TRUCK MDM MC2 (UNIMOG) CARGO
CENTRE SEATING

MODIFICATION INSTRUCTION

References: A. HQ Log Comd MM VEH (0735/92) LOG(C) 92/002541

FIG 1 - SEAT PAIRS IN POSITION WITH SECURING CLAMPS

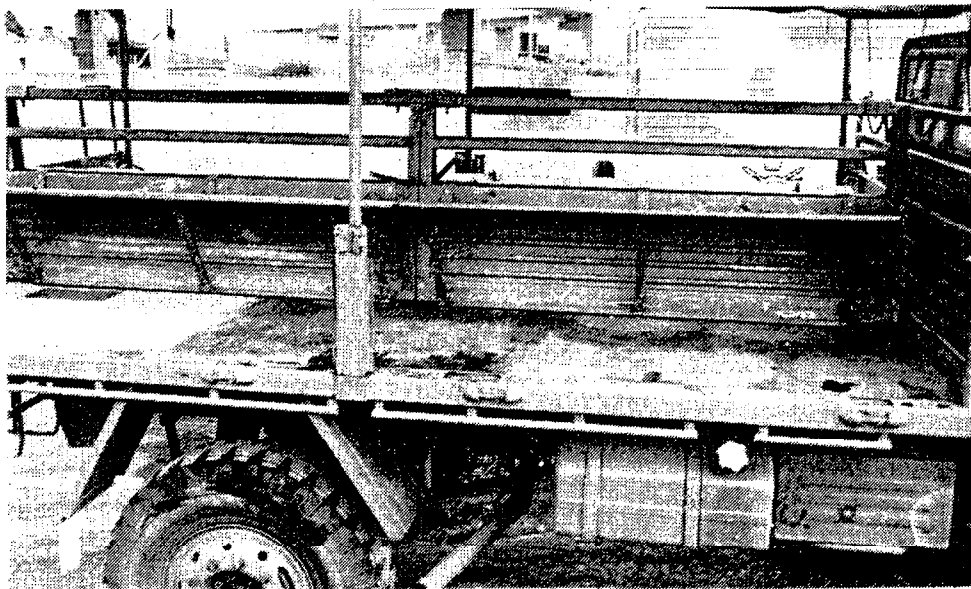
- a. Roll up the vehicle canopy.
- b. Lower the tailgate.
- c. Remove the dropsides and place them on the tray.
- d. Position the dropsides such that their hinges are in the floor locks and the dropside locks are together in the centre. Adjust the locks so that the two dropsides can sit close together.
- e. Lean each dropside out and slide the hinges over the floor lock securing pin.
- f. Move the dropside pairs together and ensure that the hinges have engaged the securing pin.
- g. Once dropsides are in position secure the seat tops by fitting the seat end clamps at the front and rear of the seat back rests, and the seat centre clamp in the centre of the seat back rest so that the front and rear seat pairs are secured together (see Fig 1).

FIG 2 - FITTING SIDE FRAMES TO VEHICLES

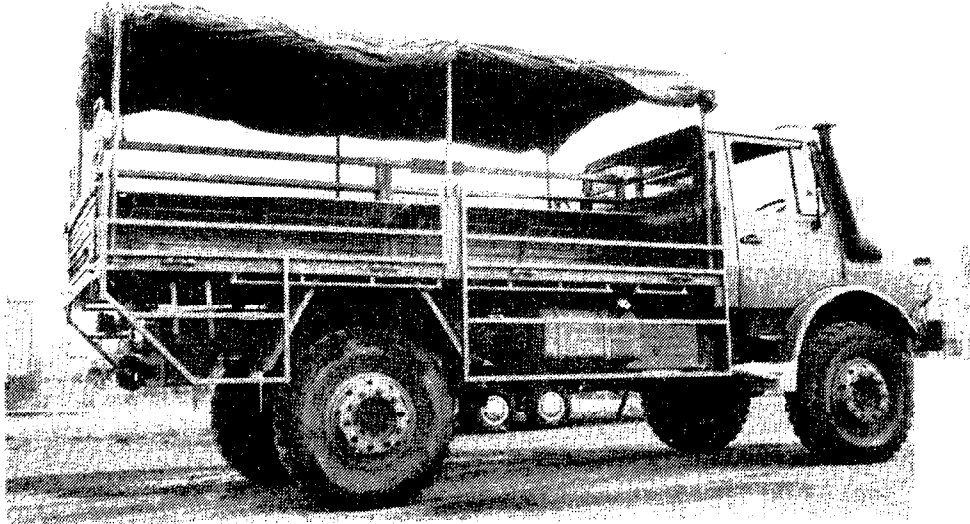
- h. Attach the side frames to the vehicle (see Fig 2), ensuring that:
- (1) The metal tangs are behind the dropside tray hinges.
 - (2) The frame goosenecks are engaged in the centre posts.
 - (3) The headboard locks are engaged in the front side frames.
- i. Raise the tailgate and secure it against the side frames using the tailgate locks.
